SOUTH CAROLINA ELECTRIC & GAS COMPANY

Subject: Virgil C. Summer Nuclear Station  
Inspection & Enforcement Bulletin  
79-02 Revision 2  
Docket No. 50-395  
Nuclear Engineering File - 2.8950

V. C. SUMMER NUCLEAR STATION  
UNIT 1  
NRC BULLETIN 79-02  
REVISION 2

FIGURE 1

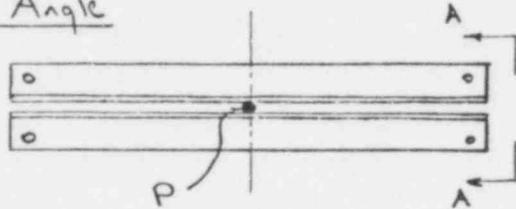
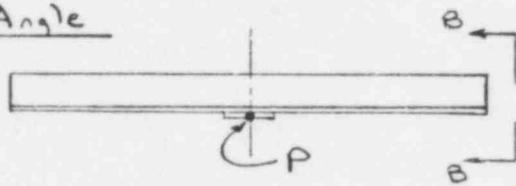
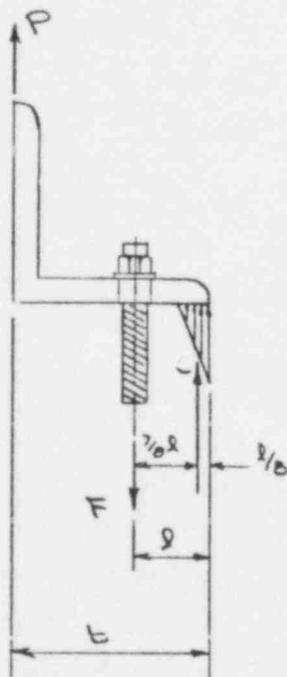
The relative low factors of safety in these cases is almost entirely attributable to the current concern that eccentrically applied loads can cause an angle to rotate about its toe, thereby forming a couple composed of a compression force in the concrete and an additional tensile force in the expansion bolt. This action, which was not adequately considered in previous analyses, can be called short direction prying and can increase the stress in the bolt to as much as 300% of that which would be determined from simple equilibrium of forces. The derivation of the factor applied to account for short direction prying is given in Figure 1.

Derivation of Short Direction Prying Factor

$$F = \frac{8P}{7l} (b - \frac{l}{2})$$

$$\therefore \text{Factor} = \frac{8}{7l} (b - \frac{l}{2})$$

FIGURE 2  
FINITE ELEMENT ANALYSIS  
OF  
TYPICAL EXPANSION BOLTED ANGLE

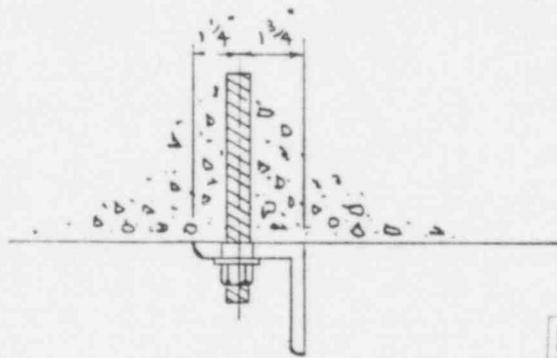
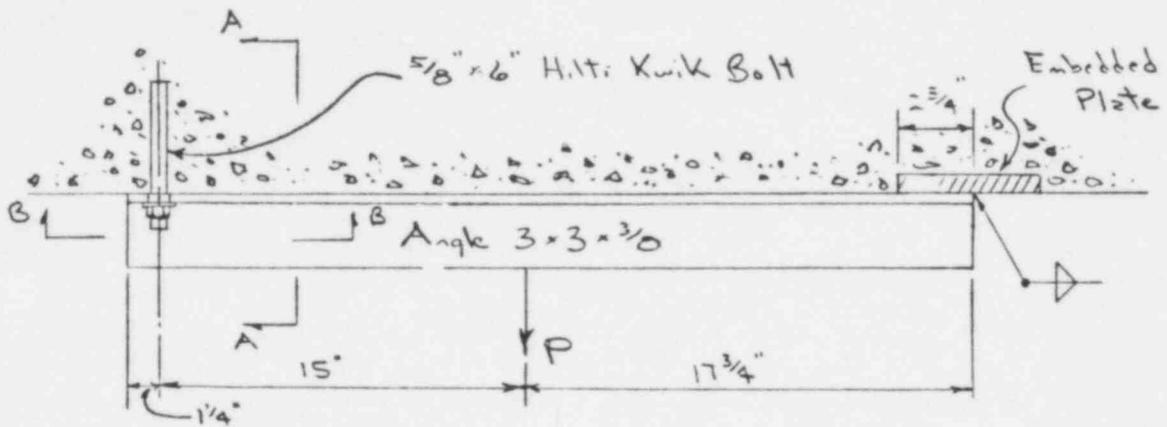
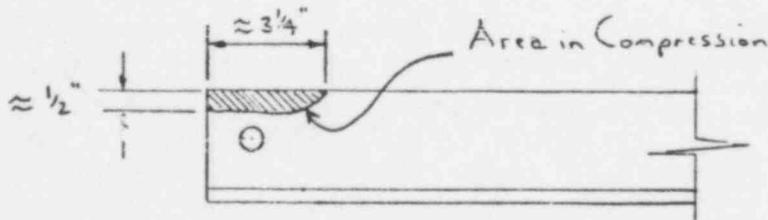
Figure 2 shows a typical application of a Hilti bolted angle. This particular arrangement using actual geometry and loads for one of the supports was analysed using finite element techniques in order to evaluate the possible effect of prying in the long direction and also the adequacy of the short direction prying analysis. That analysis confirmed that the approach being used for short direction prying was conservative and that, also as shown in Figure 2 prying in the long direction is insignificant if indeed, present at all. The distribution shows compression parallel to the long axis of the angle, as caused by short direction prying, but no additional compression along the short side of the angle as would have to be necessary if long direction prying were present. Prying in the long direction, consequently, was not considered further.

Analytical work and appropriate redesign to ensure that all pipe support anchorages formed using expansion bolted structural shapes conform to the requirements of IE Bulletin 79-02 and the ASME Boiler and Pressure Vessel Code, Section III, will be included in the design verification efforts for Seismic Category 1 supports. Such efforts will be completed prior to placing plant systems into operation.
